**REMARKS**

**AMENDMENTS TO THE DRAWINGS:**

**Fig. 1**

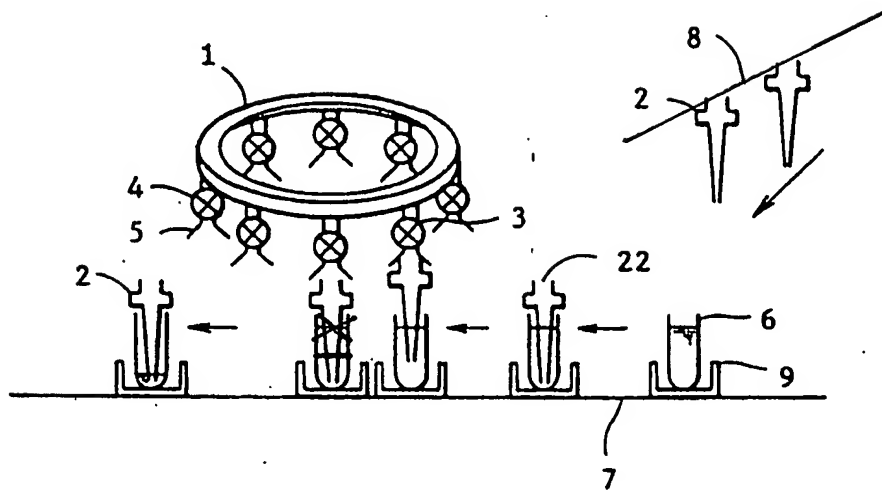
The attached sheet of drawings includes changes to Figure 1 and Figure 2. This sheet replaces the original sheet including Figure 1 and Figure 2. In Figure 1, the “suction line” is depicted by a diagonal line on the right side of the drawing. In addition, the blood level of the second blood collecting tube from the left is lowered in Figure 1. Further, the lead line of reference character “8” is corrected. In Figure 2, reference character “1” is changed to “1”
